Natural Resources Division

Project Review Summary

March 2025

Prepared for the Environmental Advisory Board

PPRE-25-00374 - Flexi-Space - 12994 S Tamiami Trl - PID 0997050005

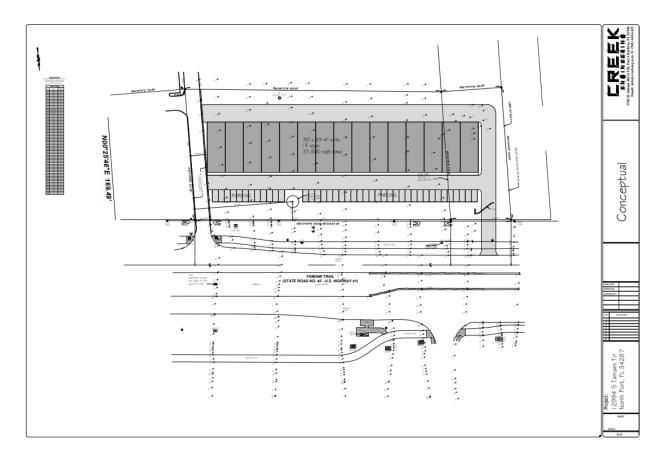
This is a pre-application review rather than a decision-making process review. To proceed with a formal submission, certain requirements are mandatory.

A professionally signed landscape plan is essential, and the project must comply with sustainable development standards by incorporating Low Impact Development (LID) practices, such as minimizing impervious surfaces and implementing green infrastructure. Additionally, landscaping for parking areas must consist of at least 10 square feet of green space per parking space, include terminal landscape islands, and feature a 5-foot-wide landscaped perimeter with canopy trees. Additionally, a privacy barrier is required to shield headlights from public areas.

PSDPA-25-00694 - COCOPLUM ADDITION - MEDICAL - 5900 S SUMTER BLVD

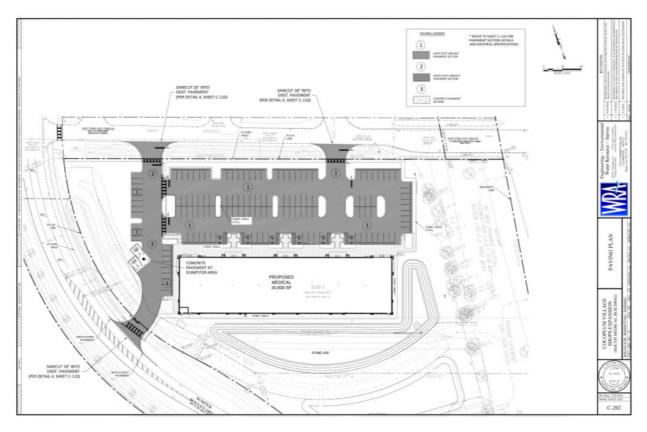
The applicant proposes to remove a paved drop-off area in front of the building and replace it with landscaping. We do not have any comments or concerns regarding this plan amendment.

PSDP-25-00794 - Sunexus Apartments at North Port - 0 Adina CIR, NORTH PORT, FL 34291 - PID 0967059219

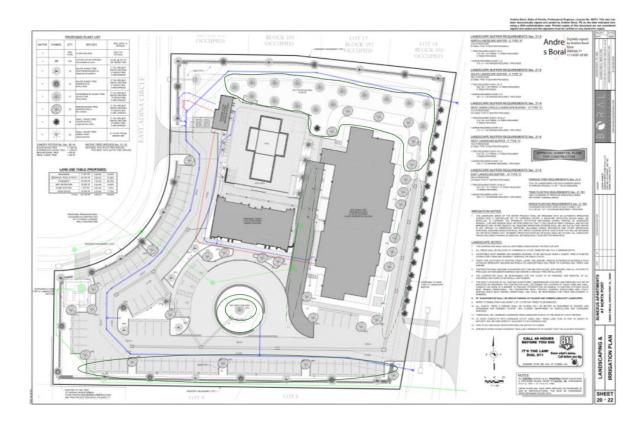
The applicants has to provide an environmental assessment featuring a wildlife survey, a vegetative survey with a site plan, and identification of wetlands, including an approved Wetland Jurisdictional Survey, if applicable. Additionally, a Tree Survey is necessary for activities involving trees eligible for mitigation or conservation. Furthermore, developments must align with sustainable practices, promoting Florida Green Building Standards, LEED Certification, and Low Impact Development (LID) designs, which may include features like rain gardens and the use of native plants. Finally, there is a minimum open space requirement of thirty-five percent for residential developments with multiple-family structures or clustered dwelling units.

PMCP-24-00000041- 75 Park Place, North Port, FL 34286 - PID 0959115475

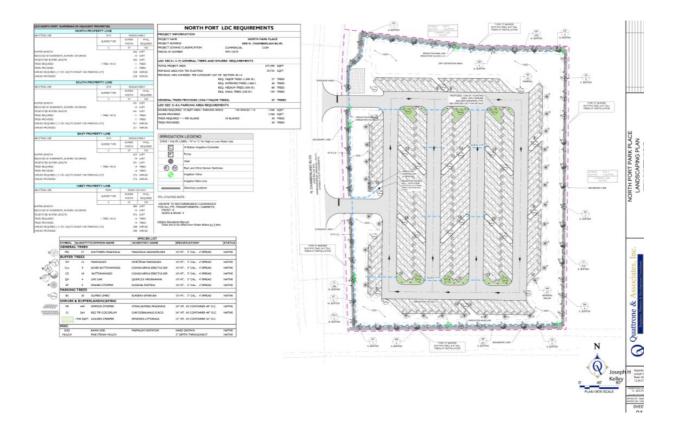
The applicant responded to our requested revisions from September 9, 2024. However, these documents are insufficient and do not comply with the regulations outlined in the Unified Land Development Code (ULDC). We recommend additional revisions to this project.

Overall Comment: The application requires further revisions due to its failure to adequately address the open space and landscaping requirements and the preservation of heritage trees in accordance with the City of North Port Unified Land Development Code. The Master Concept Plan lacks a comprehensive strategy for preserving an appropriate percentage of these significant trees, which are essential for maintaining the site's ecological integrity and aesthetic value. The revised plan must incorporate the recommendations for tree preservation along the north and east property boundaries to comply with the relevant regulations and enhance the site's landscape.
